Design Note

122 Castelnau, LONDON, SW13 9EU

In support of the Application to discharge conditions 'U0191885 Approved Plans' and 'U0193889 Approved Plans', to reflect the amended rooflight strategy, in approved applications '24/2161/VRC and '24/2672/VRC'.

Fig.1 - View from Main Road.

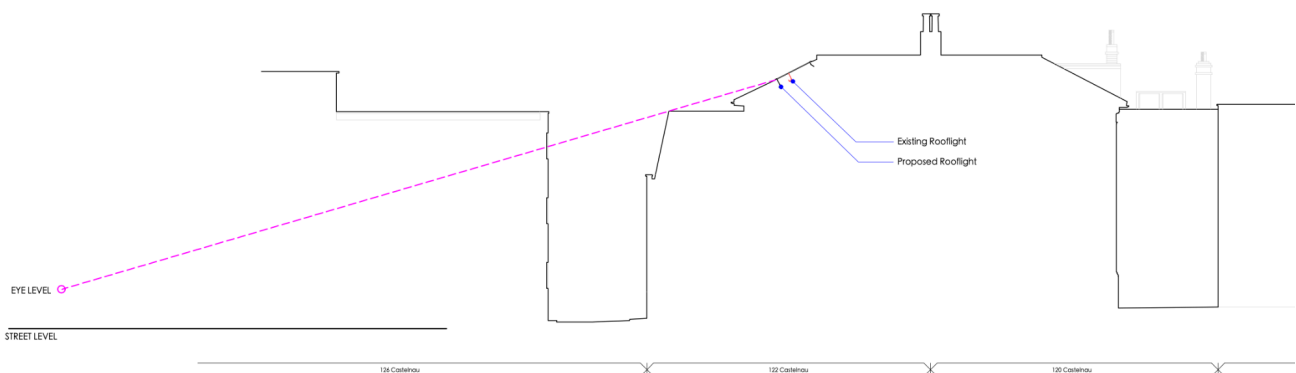
The objective of this Section 73 application is to amend the proposal to preserve the position of the existing top and sides of the rooflight opening and only enlarge the opening downwards to the top side of the repositioned purlin. This adjustment results in a taller rooflight, which will further improve the headroom above the stair. The benefit of the above proposal is that we will achieve a larger window which is desirable, without losing any more historic fabric than what we already have approval for in applications '22/2522/HOT' and '22/2523/LBC'.

Importantly, the proposed arrangement would retain the current position of the rooflight trimmers and top and side flashings, thereby further minimising any disruption to the existing historic fabric and structural arrangement.

Furthermore, due to the slope and height of the main house roof, the visual difference of the proposed alterations from the main road would be negligible, as illustrated in the diagram below (Fig. 1).
